**BEFORE THE PUBLIC UTILITIES COMMISSION  
OF THE STATE OF SOUTH DAKOTA**

**IN THE MATTER OF THE  
APPLICATION OF SWEETLAND  
WIND FARM, LLC FOR FACILITY  
PERMITS FOR A WIND ENERGY  
FACILITY AND A 230-KV  
TRANSMISSION FACILITY IN HAND  
COUNTY, SOUTH DAKOTA FOR THE  
SWEETLAND WIND FARM PROJECT**

**APPLICANT’S RESPONSES TO  
STAFF’S FIRST SET OF DATA  
REQUESTS TO APPLICANT**

**EL19-012**

Figure 5-2  
Leq Sound Level Modeling Results (Wind Turbines 10 and 22 Removed)

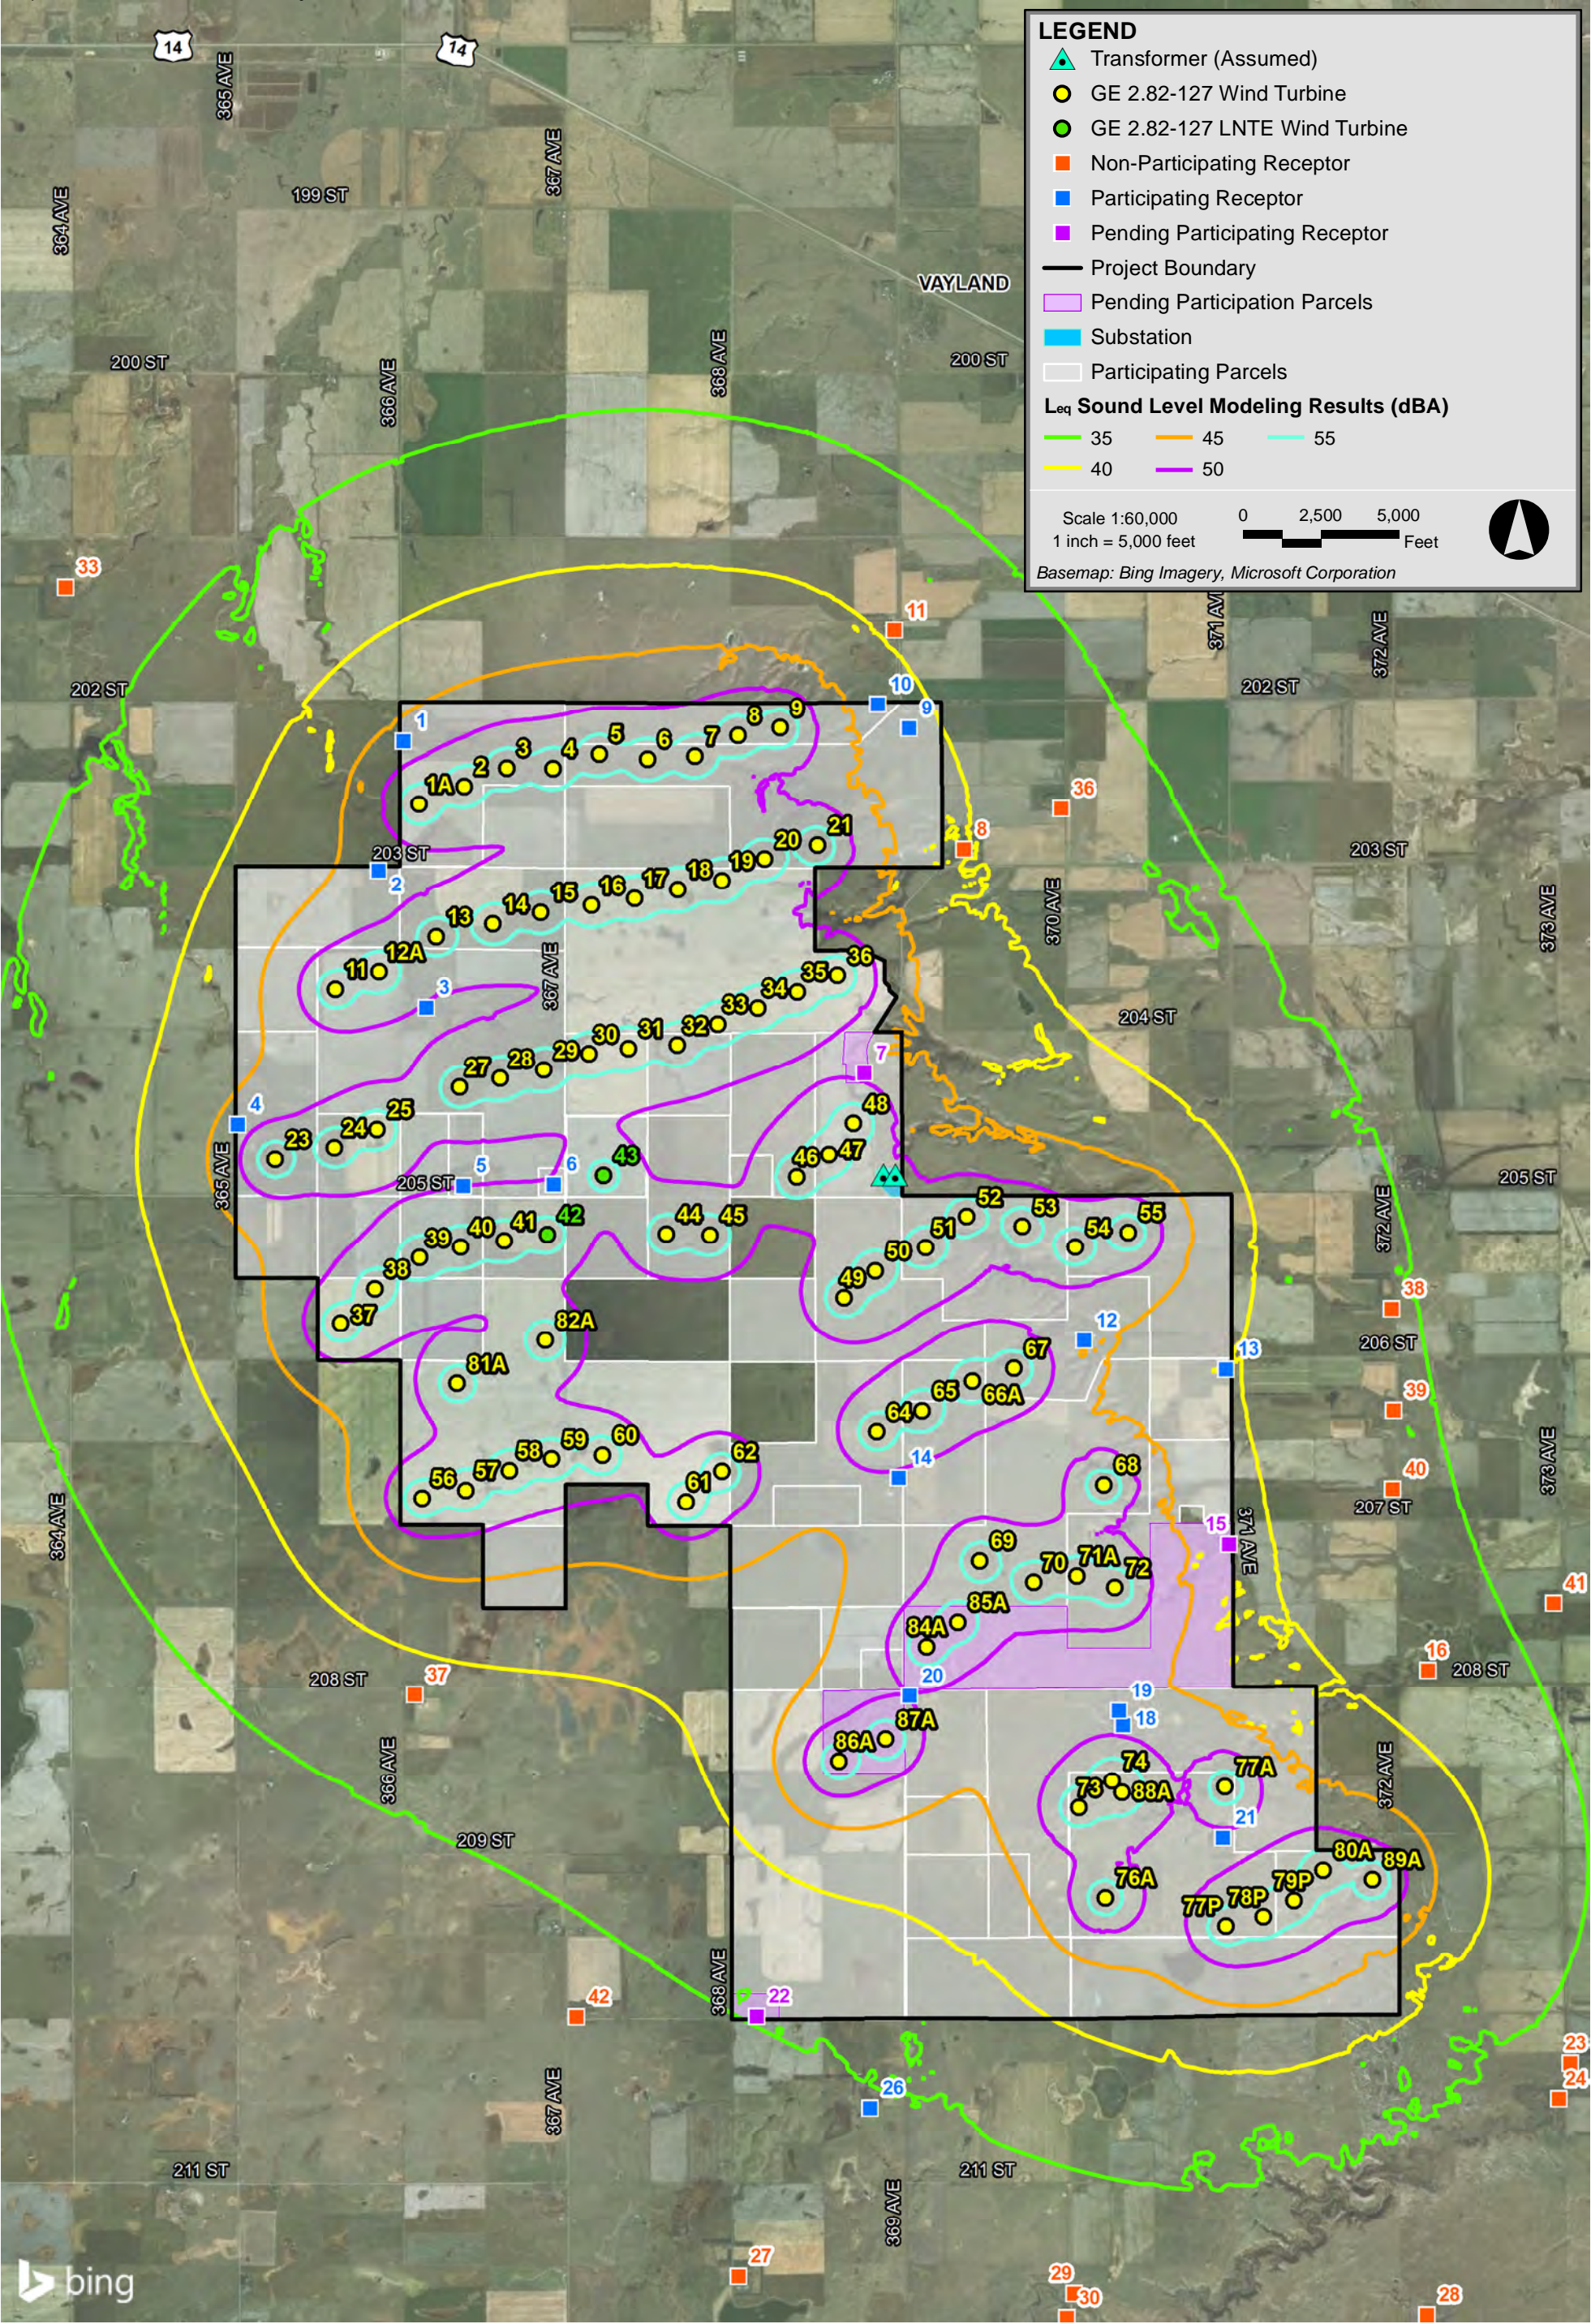
- 1-36) Refer to Appendix L of the Application, Sound Study, Figure 5-2. Please provide a revised Figure 5-2 with turbine locations 10 and 22 eliminated. Provide the expected sound level at receptors 8 and 11 with these turbine locations eliminated.

If turbines 10 and 22 were eliminated, the sound modeling results are as follows:

- Receptor 8: The modeled sound level would change from 43 dBA to 40 dBA under the modeling parameters utilized by Epsilon (which are more conservative (by approximately 2 dBA) than those utilized by Mr. Hessler in prior dockets).
- Receptor 11: The modeled sound level would change from 42 dBA to 39 dBA under the modeling parameters utilized by Epsilon (which are more conservative (by approximately 2 dBA) than those utilized by Mr. Hessler dockets).

See also Attachment 1-36. Sweetland does not support the removal of turbines 10 and 22 because:

Figure 5-2  
*Leq* Sound Level Modeling Results (Wind Turbines 9, 10, 21, and 22 Removed)

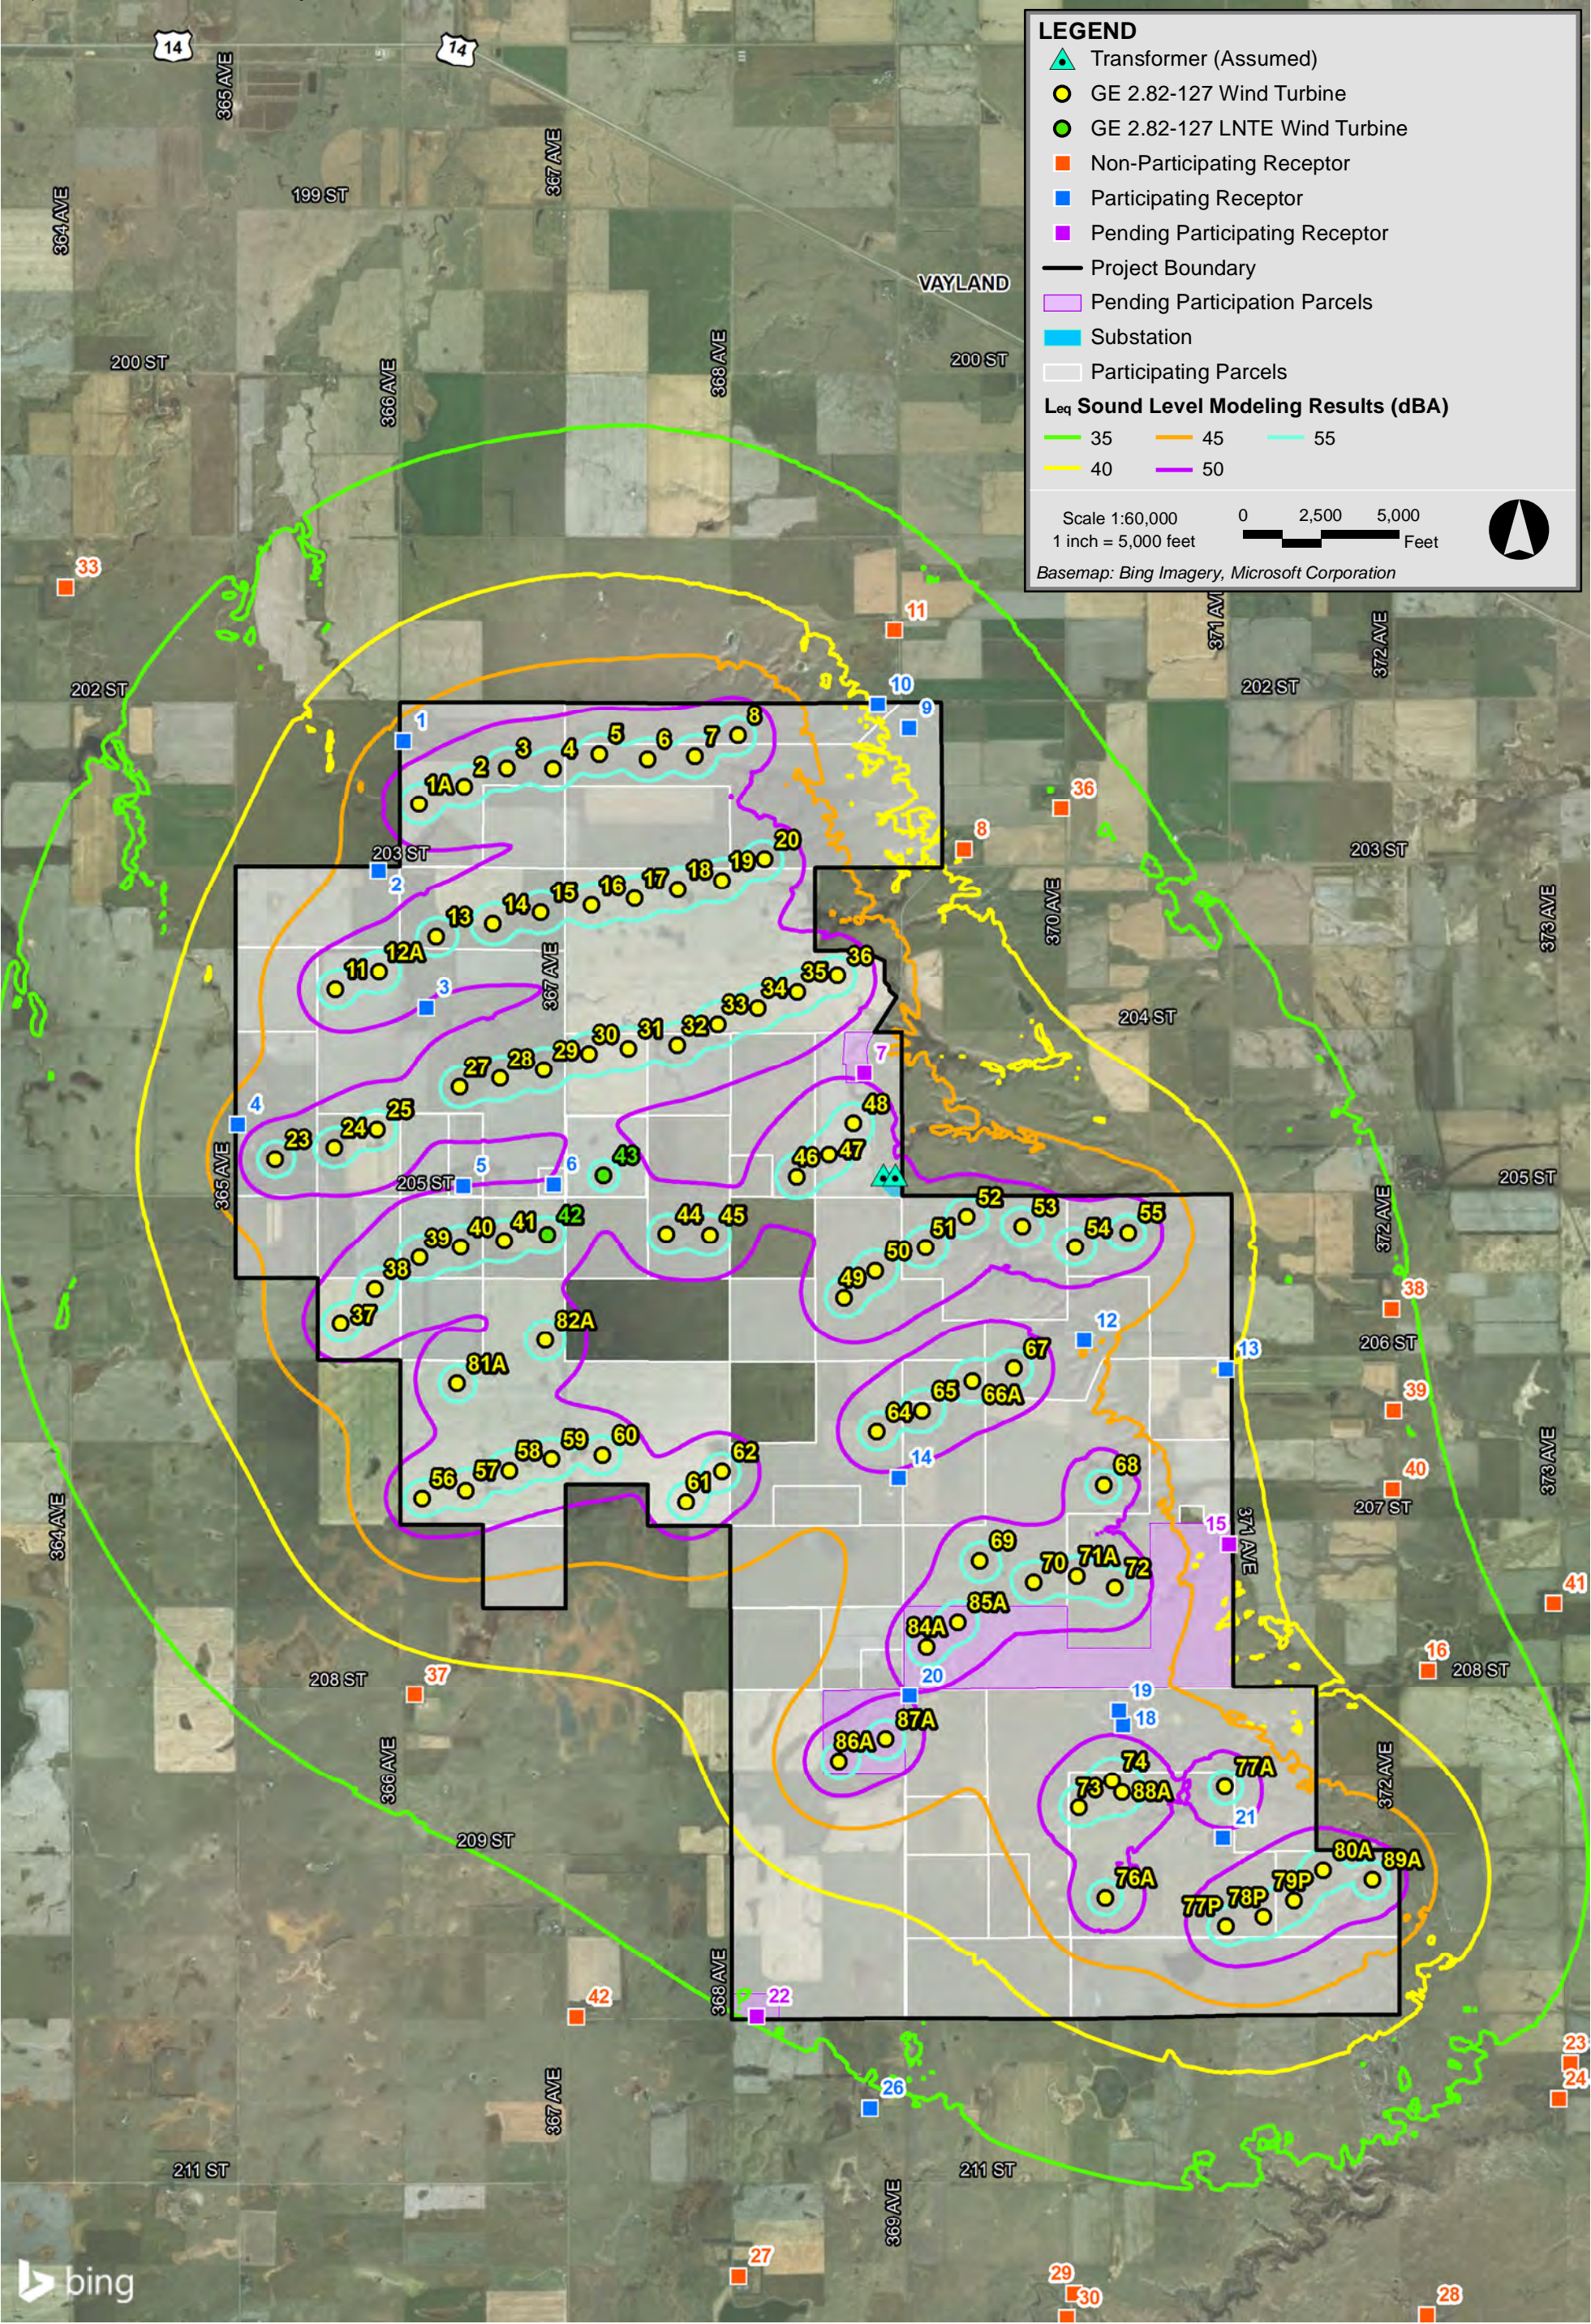
- 1-37) Refer to Appendix L of the Application, Sound Study, Figure 5-2. Please provide a revised Figure 5-2 with turbine locations 9, 10, 21 and 22 eliminated. Provide the expected sound level at receptors 8 and 11 with these turbine locations eliminated.

If turbines 9, 10, 21, and 22 were eliminated, the sound modeling results are as follows:

- Receptor 8: The modeled sound level would change from 43 dBA to 39 dBA under the modeling parameters utilized by Epsilon (which are more conservative (by approximately 2 dBA) than those utilized by Mr. Hessler in prior dockets).
- Receptor 11: The modeled sound level would change from 42 dBA to 38 dBA under the modeling parameters utilized by Epsilon (which are more conservative (by approximately 2 dBA) than those utilized by Mr. Hessler in prior dockets).
